Re: Comment Request for Agnico Eagle's Meadowbank Complex Project 2023 Annual Report

The Government of Nunavut (GN) would like to thank the Nunavut Impact Review Board (NIRB) for the opportunity to provide comments on Agnico Eagle's 2023 Annual Report for the Meadowbank and Whale Tail Pit Project (Complex), NIRB File #s 03MN107 & 16MN056.

Figure 3. GN Radio Telemetry Collar Map – May 6, 2023

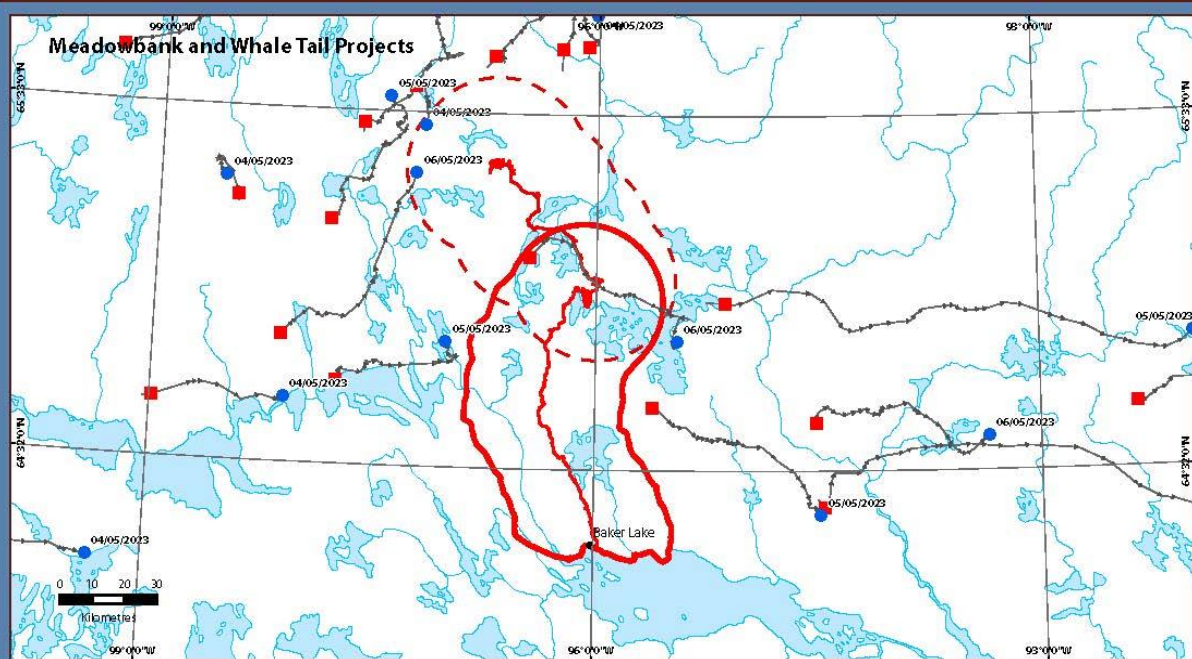
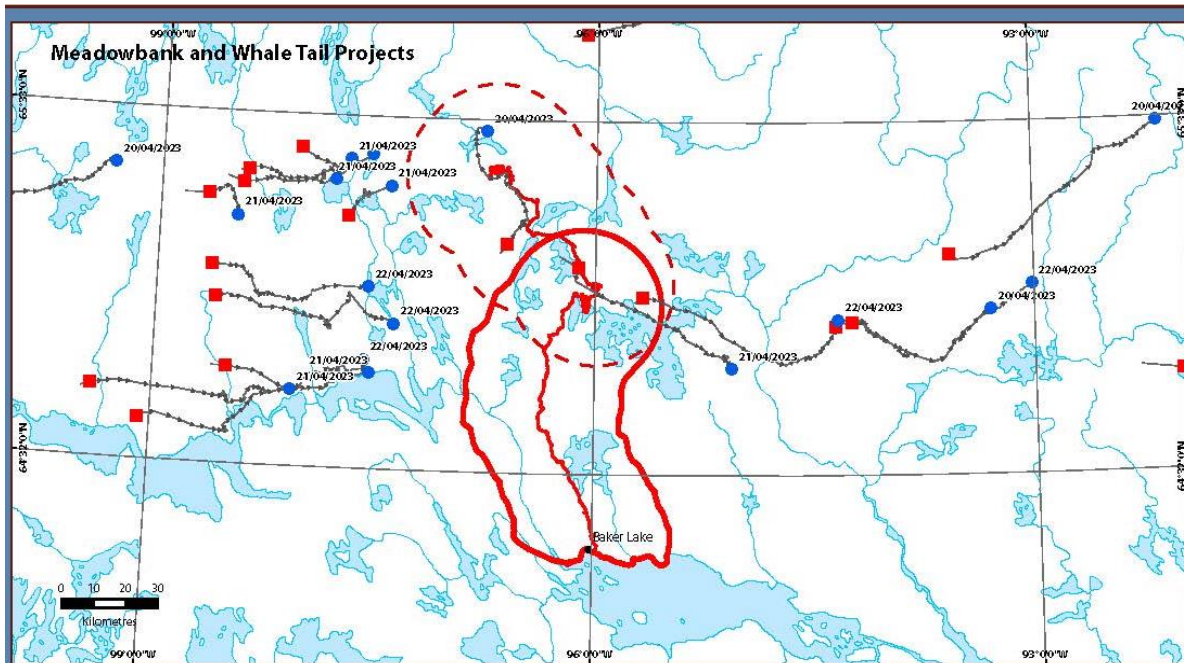
The GN notes that the TEMP's threshold for increasing the frequency (i.e., from weekly to every second day) for pit and mine site ground surveys would have been triggered multiple times during the 2023 Spring Sensitive Season as a result of collar caribou data (see Figures 1–3) that the GN provides to AEM on a daily basis (Page 6-1; AEM, 2024). Figures 1–3 illustrate that collared caribou were within 50 km of the mine site, as such, these additional ground surveys in April and May should have been conducted. As a result, it appears that AEM did not follow this requirement of the TEMP at this time.

- 1) AEM provide a detailed explanation as to why the frequency of pit and mine site ground surveys conducted at the Whale Tail Site in 2023 were not increased in April and May, as required by the TEMP (AEM, 2019).
